Bridge Square

Northfield Heritage Preservation Commission
Meeting

December 4, 2024 | 6:00pm

SHPO Review: 60% Plans

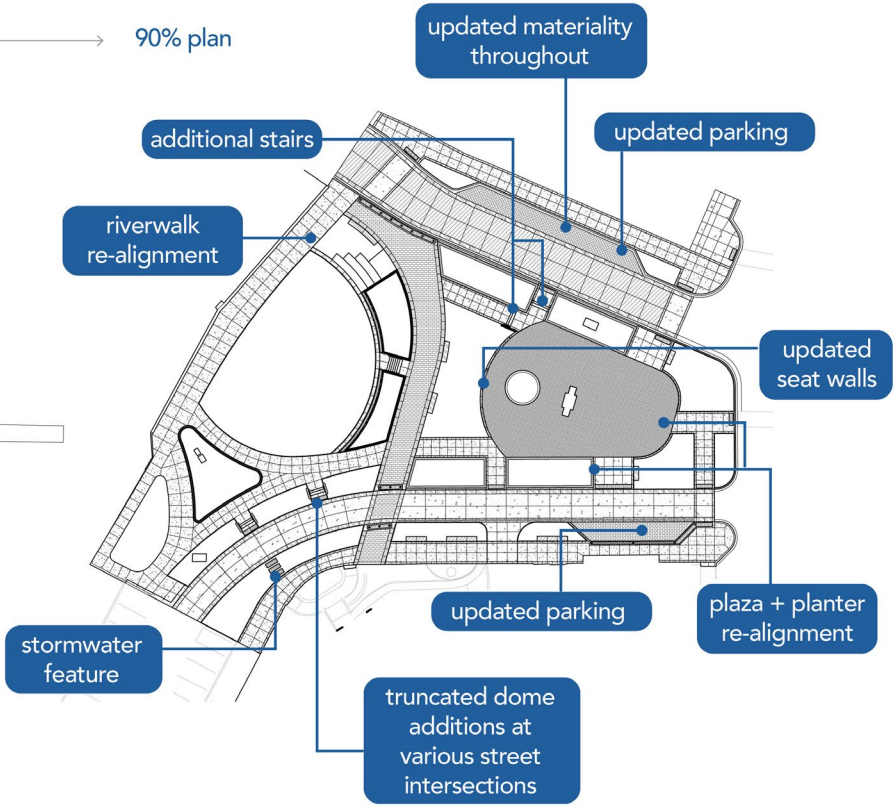
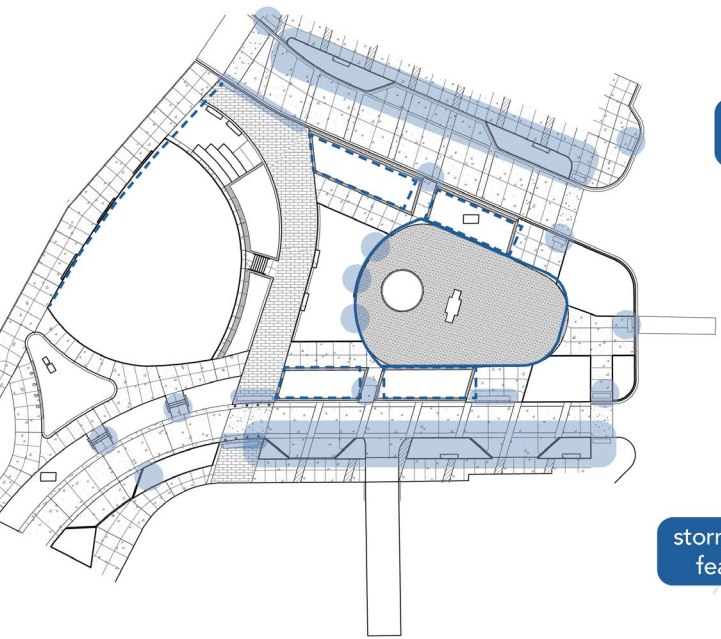
Based on our review of the submitted documentation, we are pleased to see that the **design has been refined in response to comments received from our office, the Northfield Heritage Preservation Commission, and Northfield community members.**

In our opinion, the current design is much more compatible with the forms of both Riverside Park and Bridge Square, and we have determined that **the project, as currently proposed in the 60% construction documents, has been designed in accordance with the SOI Standards.** We look forward to reviewing the 90% construction documents when they become available

90% Plans: Architectural History

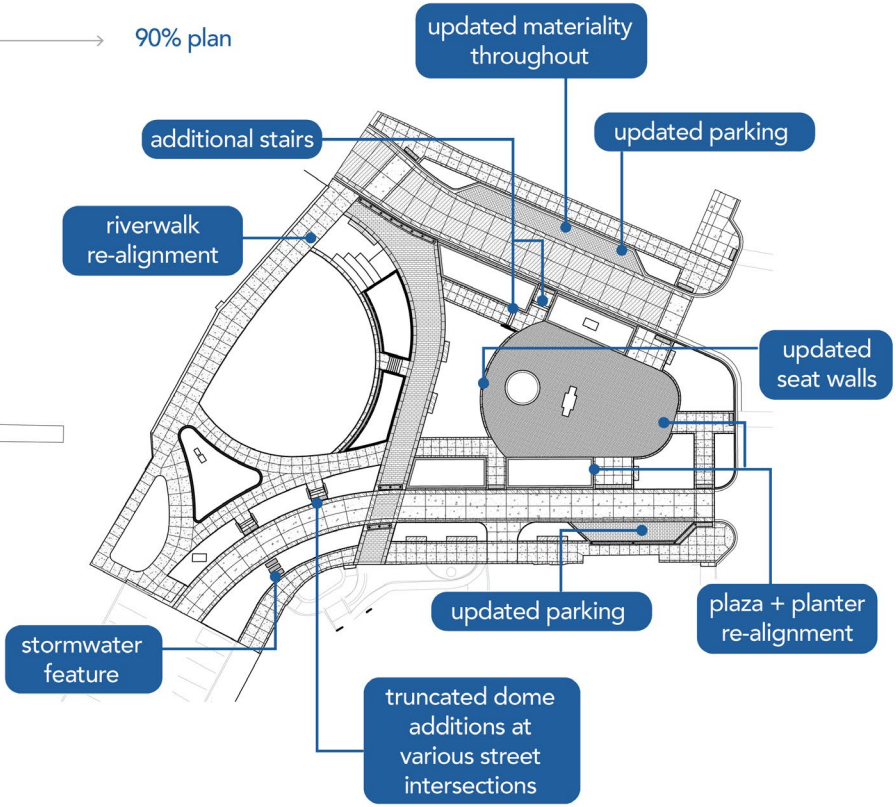
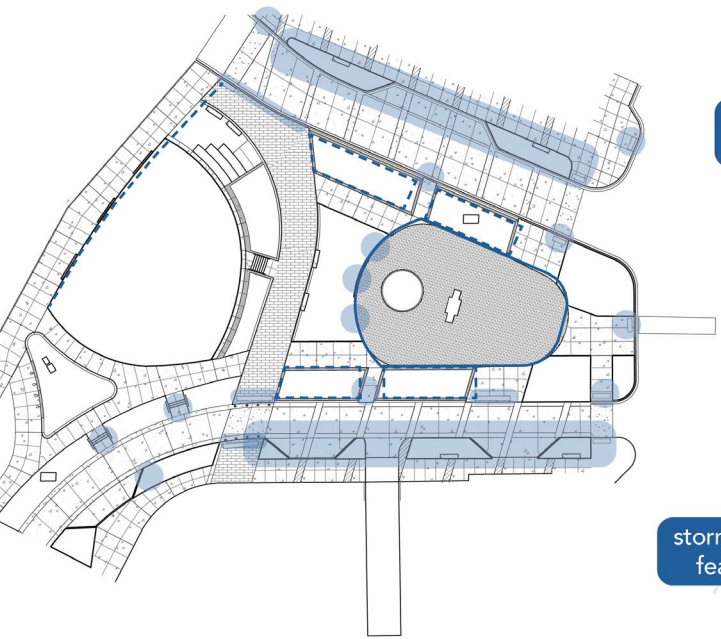
Nothing in the 90% plans requires the removal of distinctive materials or alteration of features, spaces, and spatial relationships that characterize Bridge Square
